University of South Carolina

Addendum Two

Project Name: Desegregation Commemorative Gardens

Project Number: CP00397055 Date: February 17, 2014

AD-2

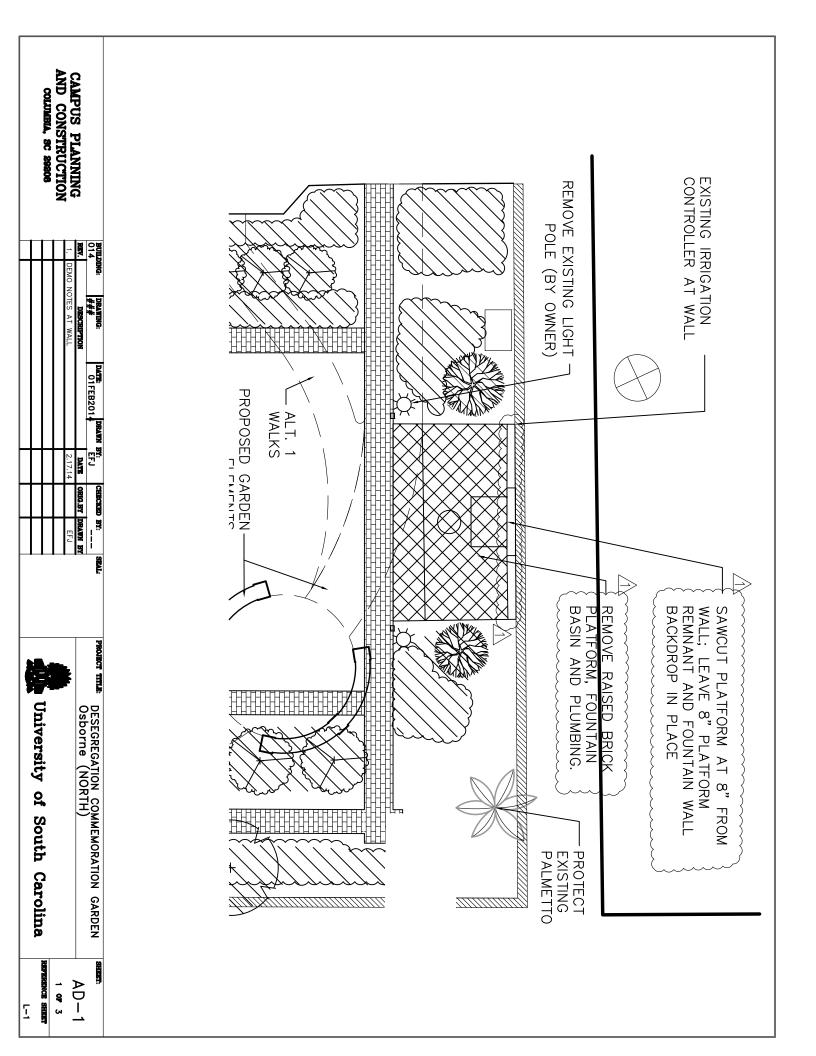
- 2. Reference Sheet L-2, Layout Plan and Site Detail Key. The brick soldier edging in a mortar bed at the path edges shall continue around the perimeter of the circular plaza area, terminating at the bench pilasters. See Addendum Sketch AD-2.

CAMPUS PLANNING
AND CONSTRUCTION
COLUMBIA, SC 20200 CONTINUE BRICK SOLDIER EDGING AT PLAZA TO BENCH PLASTERS, SET FLUSH TO PLAZA CHIRCKED BY: --- S
ORIG.BY DRAWN BY ALT #1: -BRICK PAVEMENT R 26'-4 1/2" PROJECT TITLE: University of South Carolina DESEGREGATION COMMEMORATION GARDEN OSborne (NORTH) $3'-2\frac{1}{2}"$ 1'-11" PLAN DETAIL PLAN DETAIL EFERENCE SHEET L-2 AD-22 OF 3
